Scientific Analysis/Calculation Error Resolution Document

1. Document Number: ANL-NBS-MD-000009	2. Revision/Addendum: 03/01	3. ERD: 01
--	--------------------------------	---------------

4. Title: Soil-Related Input Parameters for the Biosphere Model	5. No. of Pages Attached: 12 of 5-20-10
--	--

Figure 6.5-1. Distribution of Measured Enhancement Factors

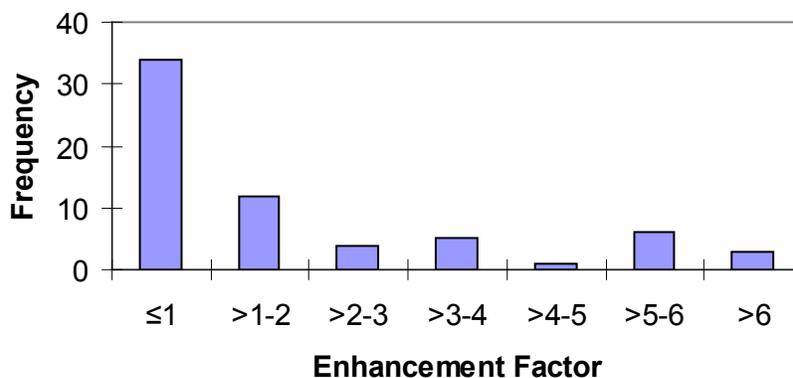
The histogram in Figure 6.5-1 does not show the appropriate bin intervals. The intervals should include the greater than sign (>) on the lower interval number. Figure 6.5-1 on pg. 6-35 of *Soil-Related Input Parameters for the Biosphere Model* (ANL-NBS-MD-000009 REV 03 AD 01 [DIRS 179993]) is replaced with Figure 6.5-1 below showing the correct binning intervals:

The corrections to the bin intervals used in developing Figure 6.5-1 are discussed in this ERD, therefore it is not necessary to update the data CD associated with Appendix A. The correction to this table does not affect the results or conclusions of this report, its downstream documents, or the license application.

Figure 6.5-2. Graph of Enhancement Factors for Undisturbed and Disturbed Soil Conditions

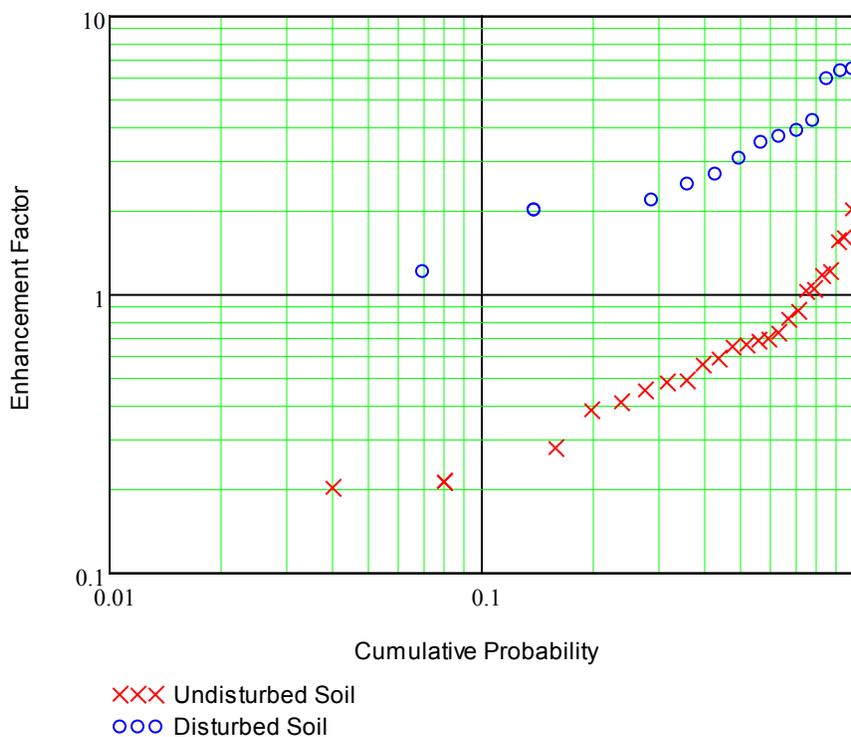
In Appendix A CD file *EFS for undisturbed and disturbed soil.mcd*, enhancement factors for undisturbed soil were taken from several references listed in Table 6.5-2 rather than Table 6.5-3 of the report. Also, enhancement factors for the disturbed soil were taken from several references listed in Table 6.5-3 rather than Table 6.5-4 of the report. The first number for the matrix AD0 should be 4.2 instead of 7.2. For AD0, as it is a CDF (sorted from largest to smallest), the order needs to be changed. The values 6.5, 6.4 and 6 move up. The value of 4.2 is placed in the 4th position. These corrections result in changes to Figure 6.5-2.

Figure 6.5-2 on pg. 6-39 of *Soil-Related Input Parameters for the Biosphere Model* (ANL-NBS-MD-000009 REV 03 AD 01 [DIRS 179993]) is replaced with Figure 6.5-2 below showing the correct enhancement factor CDFs. The corrections to calculations used in developing the replacement Figure 6.5-2 are discussed in this ERD, therefore it is not necessary to update the data CD associated with Appendix A.

Changes to this figure are negligible at this scale; therefore do not affect the results or conclusions of this report, its downstream documents or the license application.
